Errata sheet V1.5 affecting products TC23x_AC

N° 10210AERRA

Subject: TC23x_AC_Errata_Sheet_v1_5

Device TC23x
Marking/Step ES-AC, AC
Package see Data Sheet

Figure 3 Message RAM Configurations

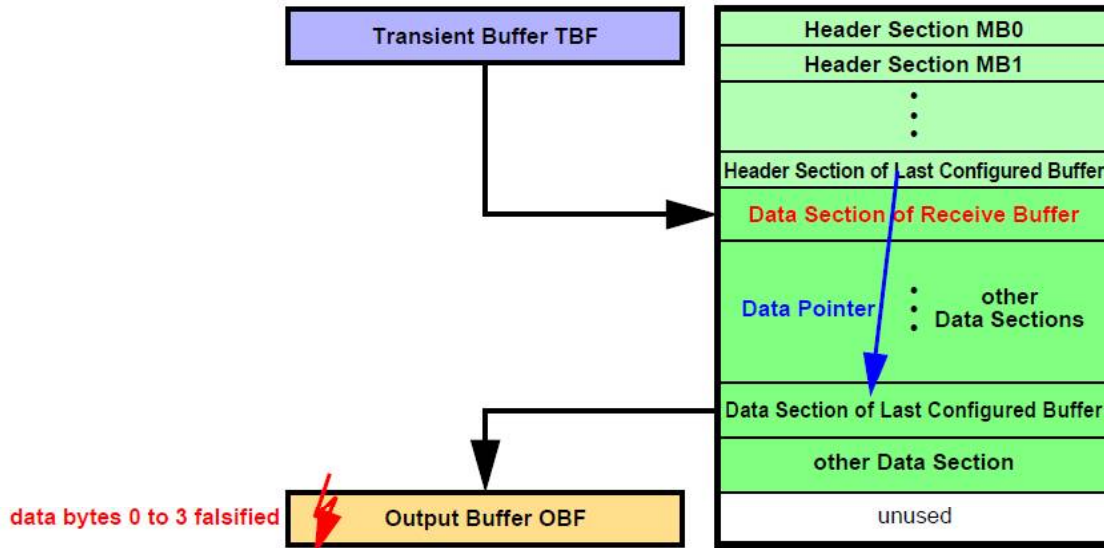
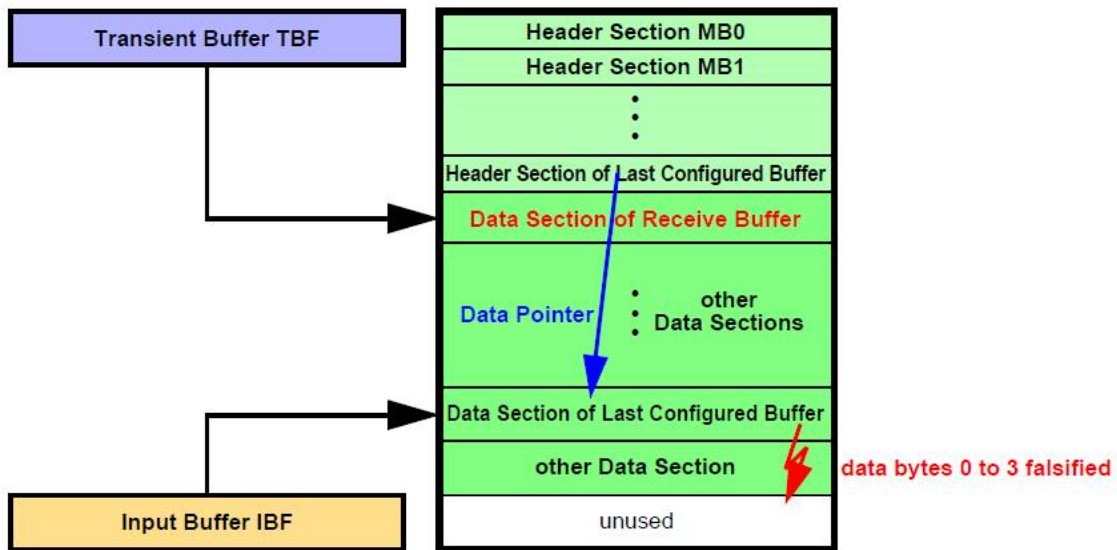
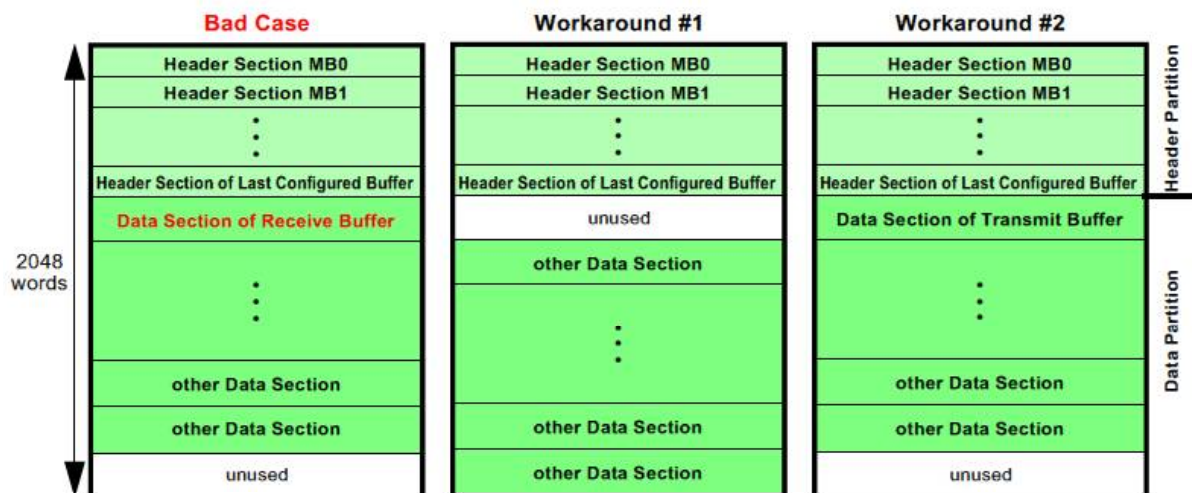
When the message buffer has its payload configured to maximum length (**PLC** = 127), the OBF word on address 00h (payload data bytes 0 to 3) is overwritten with unexpected data at the end of the transfer.

After the Data Section of the selected message buffer in the Message RAM has been written, one additional write access overwrites the following word in the Message RAM which might be the first word of the next Data Section.

- a) When a message is transferred from the Last Configured Buffer in the Message RAM to the OBF and **PLC** = 127 it may happen, that at the end of the transfer the OBF word on address 00h (payload data bytes 0 to 3) is overwritten with unexpected data (see [Figure 1](#)).
- b) When a message is transferred from IBF to the Last Configured Buffer in the Message RAM, it may happen, that at the end of the transfer of the Data Section one additional write access overwrites the following word, which may be the first word of another message's Data Section in the Message RAM (see [Figure 2](#)).

2) Ensure that the Data Section directly following the Header Partition is assigned to a transmit buffer.

Figure 5 Transmitter - loosing CAN FD node

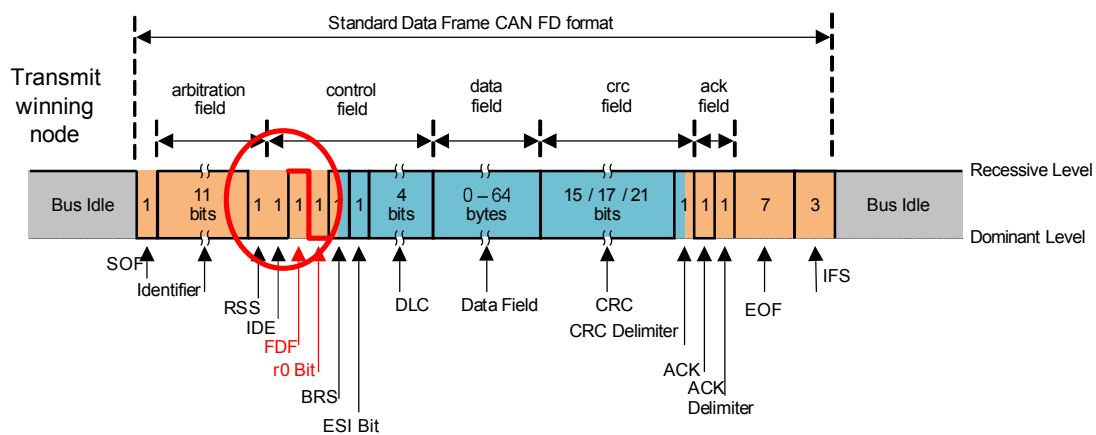
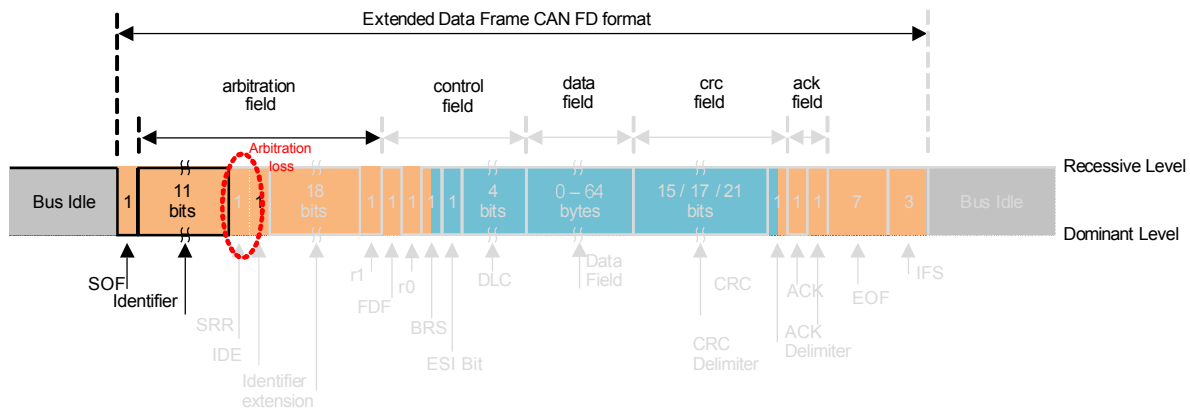
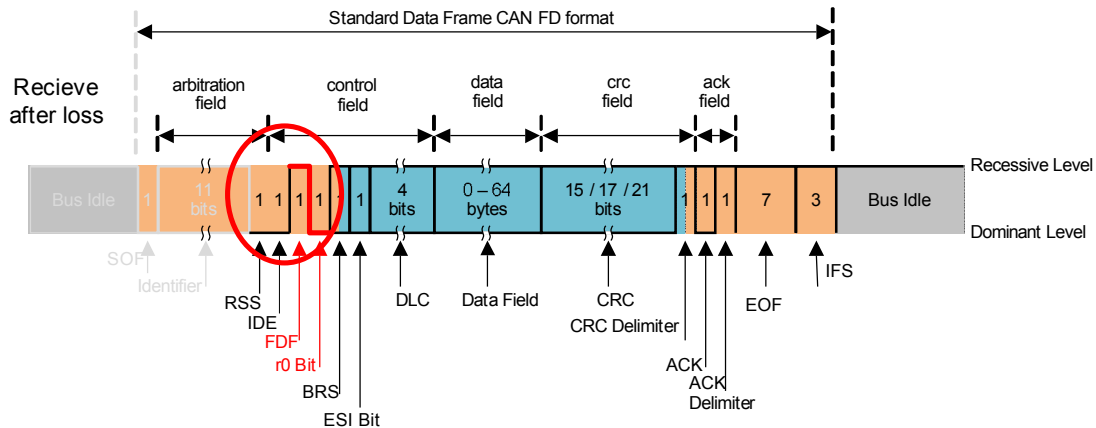
If a transmitter is losing arbitration late (e.g. in an extended frame - see [Figure 4](#) the node which wins arbitration and [Figure 5](#) the transmitting node loosing arbitration), then the FDF bit to res bit is the last chance to synchronize to the

winning node (here as a receiver [Figure 6](#) the same node as in [Figure 5](#)). A timing offset will occur between the now receiving node and the actual transmitter.

The device is producing more error frames within a network than a device with a hardsync at the FDF bit.

Figure 12 Ripple Voltage vs. Frequency Characteristic

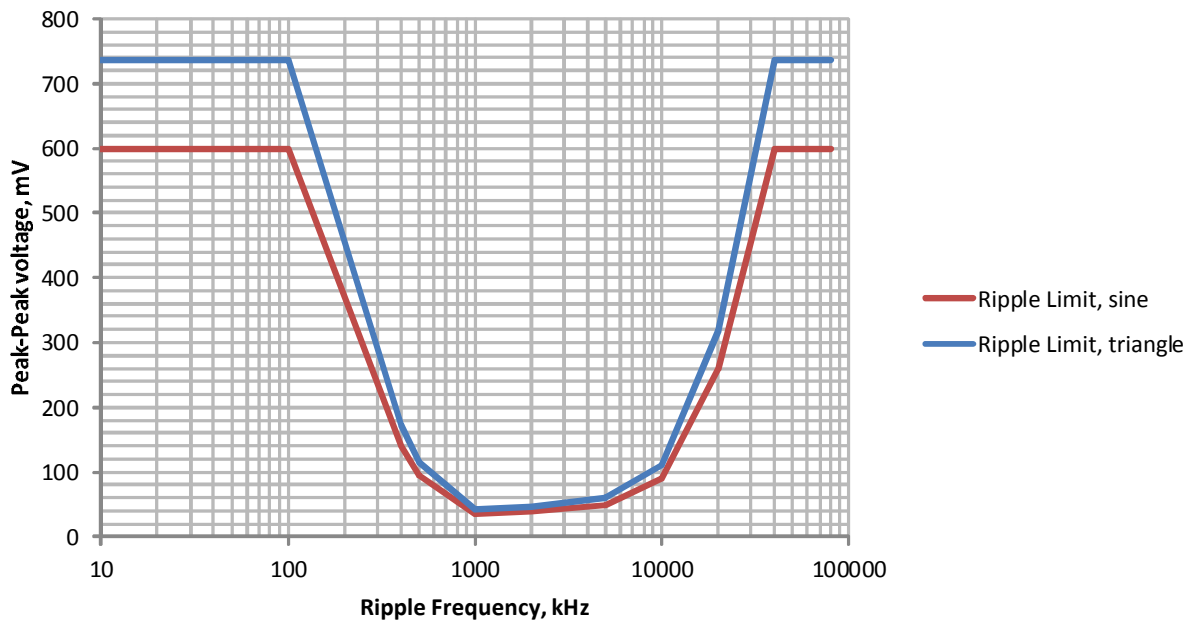
The internal back-up clock is sensitive to specific power supply voltage disturbance/ripple caused by a voltage ripple intrinsic to DC-DC converters. Specific conditions such as insufficient filtering of the ripple may lead to improper behavior of the start-up scheme of the back-up clock, and thus stuck-at state during the start-up of the microcontroller until this condition is removed.

The acceptable voltage vs. frequency characteristic is portrayed below on the chart:

The diagram reflects acceptable ripple level during the cold start of the microcontroller at the respective VDDP3/VEXT/VEVRSB supply of the PMS subsystem, depending on the device and package type, as shown in the following table.

Figure 13 Short Serial Message, Serial Data Encoding over 16 messages

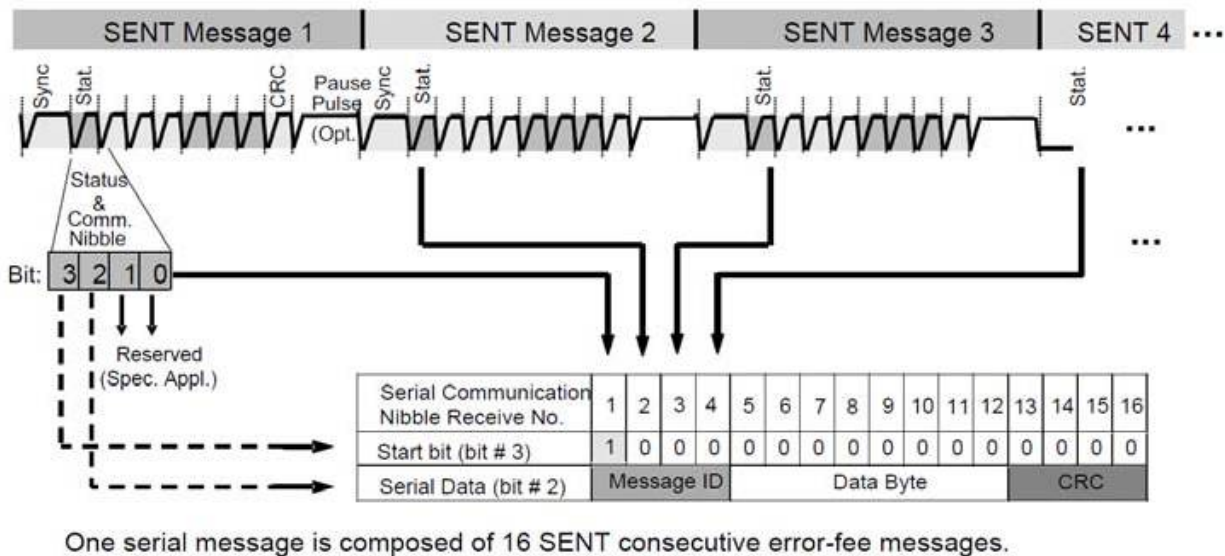
Figure 13 shows a corrected version of this figure.
